<b>V-24-06</b>	<b>Staff Report – May 16, 2024</b>										
<b>Application Type:</b>	Area Variance										
<b>Summary of Proposed Action:</b>	Applicant is seeking relief, in regarding to the standards of MX-4 Zone District, to establish a “projecting sign” on the south elevation of a multi-unit dwelling apartment, named “The CODA”. The proposed sign will exceed maximum sign area, maximum sign face height, maximum projecting distance from building façade, and to be located above the third floor.										
<b>Project Address:</b>	301 South Crouse Avenue & East Genesee Street (Tax Map ID: 048.-05-04.3)										
<b>Owner/Applicant</b>	TLSP CODA LLC (Owner) James Trasher, CHA Consulting Inc. (Applicant)										
<b>Zoning Violations</b>	<p>The proposed project is seeking an area variance from the Board of Zoning Appeals to violate the following Zoning Ordinances:</p> <ol style="list-style-type: none"> <li>1. ReZone, Art. 4, Sec. 4.8H(2), Sign regulations for MX-4 Zone District: Maximum sign area for Projecting Sign is 10 SF.</li> <li>2. ReZone, Art. 4, Sec. 4.8H(2), Sign regulations for MX-4 Zone District: Maximum sign face height for Projecting Sign is 4 FT.</li> <li>3. ReZone, Art

2 SOUTH ELEVATION (EAST GENESEE STREET)  
A.02 SCALE: 1/16" = 1' - 0"

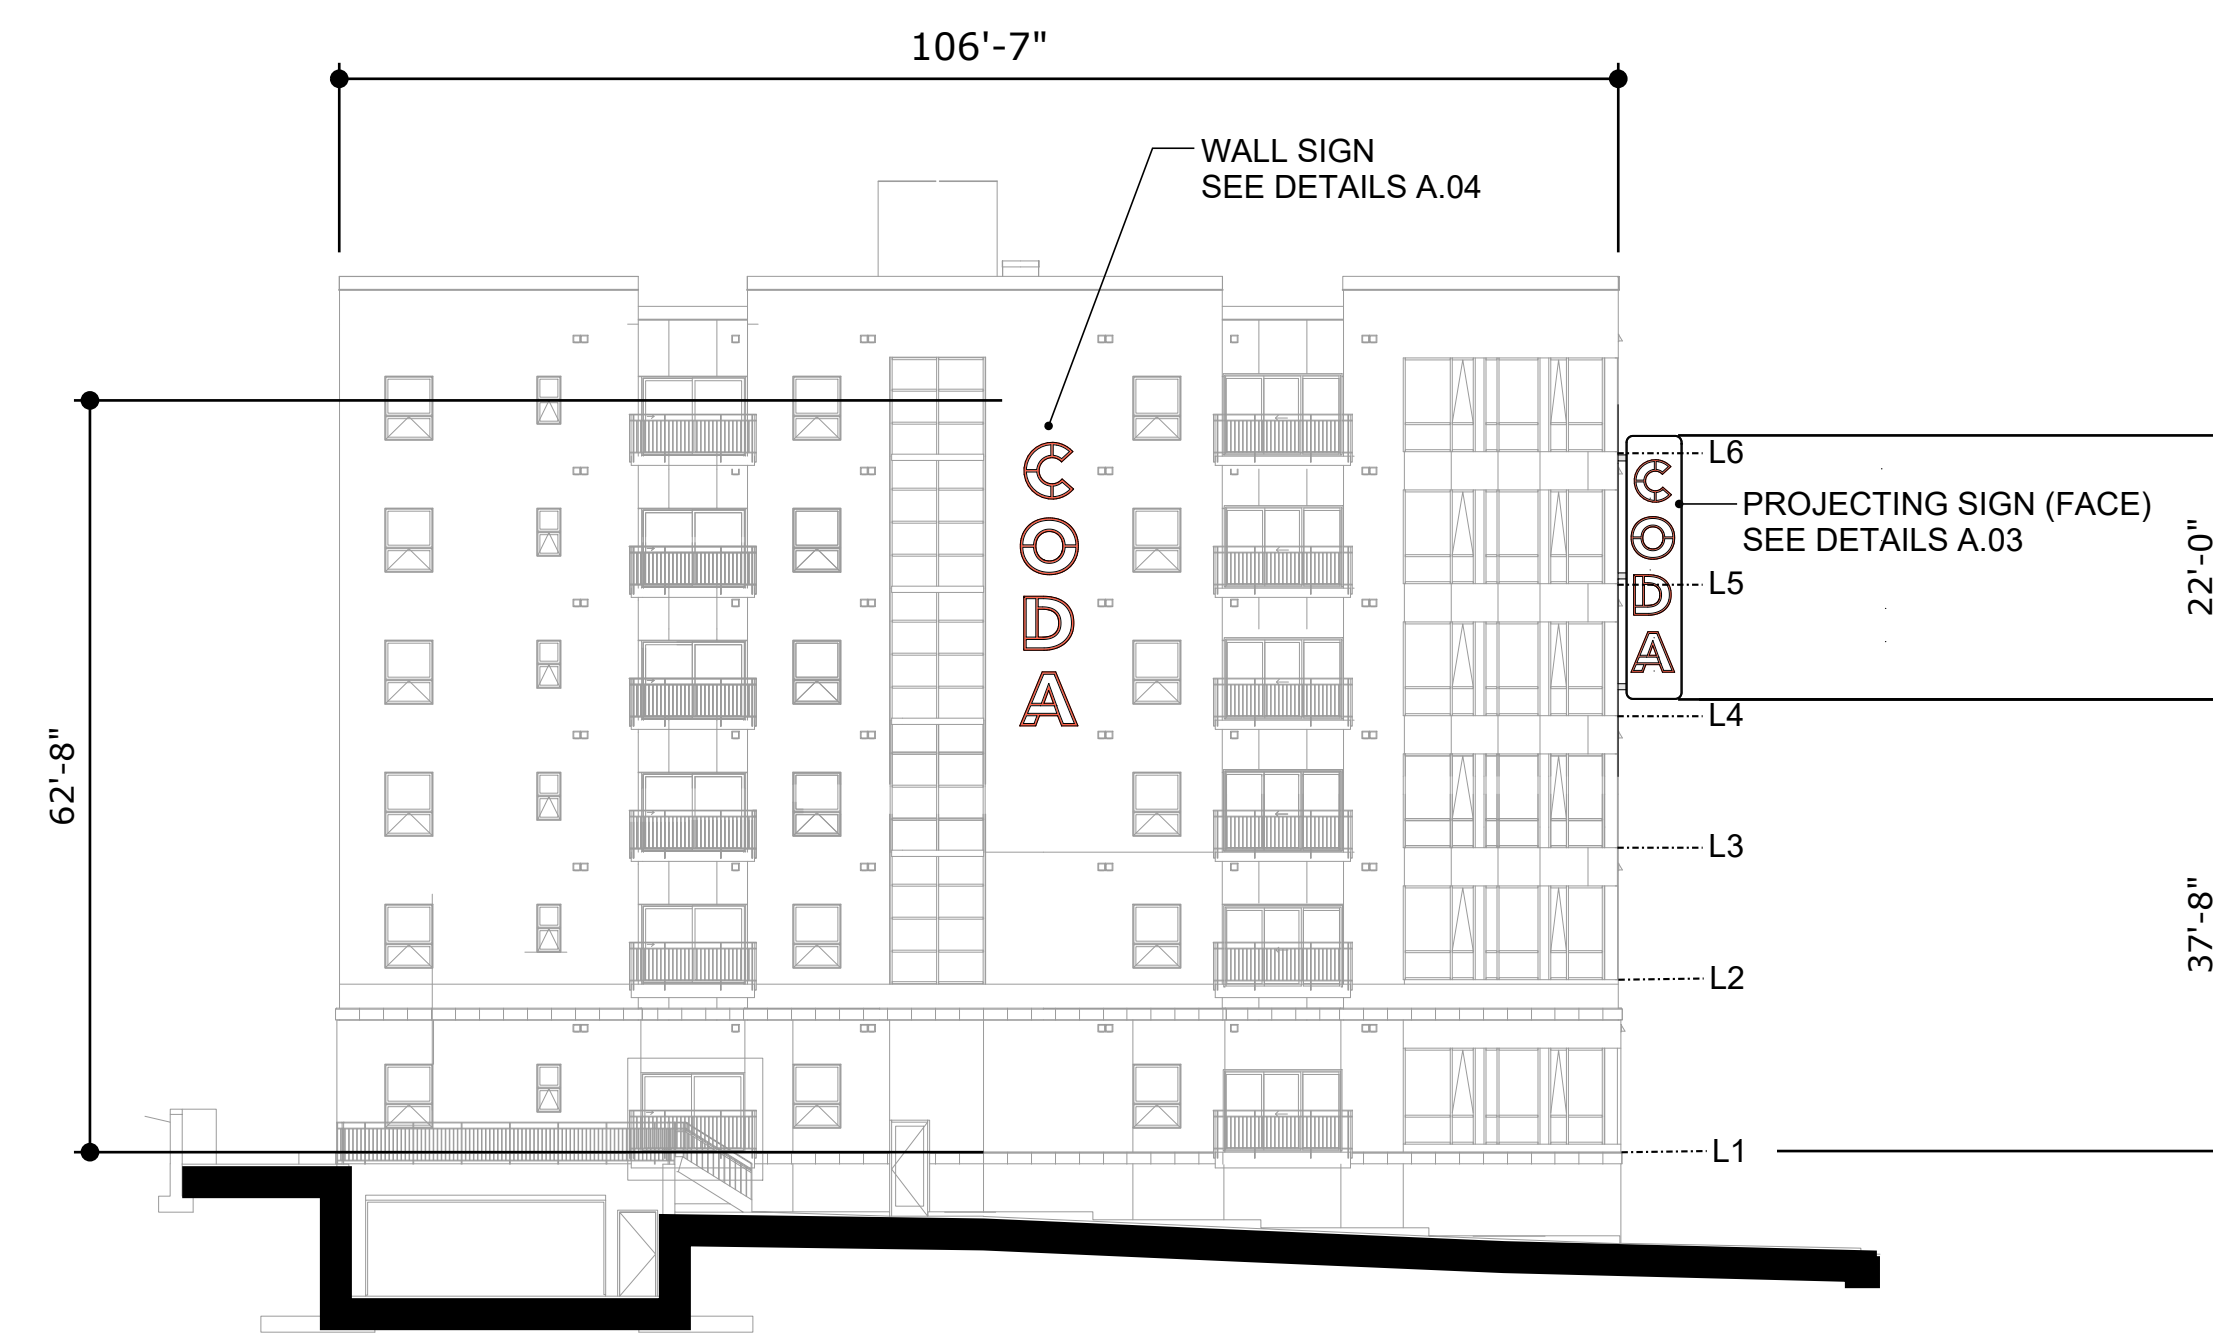
<p><b>Staff Analysis:</b></p>	<p><b>Factors:</b></p> <ul style="list-style-type: none"> <li>• The CODA apartment is a six-story building with a 145.583 FT of south elevation facing East Genesee Street.</li> <li>• The proposed sign will be located above the third floor.</li> <li>• The proposed sign will be internally illuminated by LED lights.</li> <li>• The SLPB reviewed the application materials at its 5/9/24 meeting. The SLPB determined that the scale of the proposed projecting sign facing E. Genesee Street ("Sign 3") would have a negative impact on the historic character of the National Register-eligible residence at 1029 E. Genesee St (former Dr. Levy House). Mike O'Shea (QPK Architects) who was present at the meeting on behalf of the applicant suggested that the sign could be reduced in size and lowered to a point just above the horizontal line immediately above the ground floor storefronts. The SLPB agreed that this design revision would address its concerns regarding the scale of the sign in relation to the historic residence.</li> </ul>

The Board generally discourages allowances for such substantial signage variances, which can dominate the façade of the building and detract from desired community character.

Approval	Status	Status Date	Reviewer	Comments
Board of Zoning Appeals	Pending	03/18/2024		
Zoning Planner	On Hold	05/07/2024	Zhitong Wu	On hold for approval from BZA.
Landmark Preservation Board	On Hold	04/23/2024	Kate Auwaerter	The SLPB reviewed the application materials at its 5/9/24 meeting. The SLPB determined that the scale of the proposed projecting sign facing E. Genesee Street ("Sign 3") would have a negative impact on the historic character of the National Register-eligible residence at 1029 E. Genesee St (former Dr. Levy House). Mike O'Shea (QPK Architects) who was present at the meeting on behalf of the applicant suggested that sign could be reduced in size and lowered to a point just above the horizontal line immediately above the ground floor storefronts. The SLPB agreed that this design revision would address its concerns regarding the scale of the sign in relation to the historic residence.
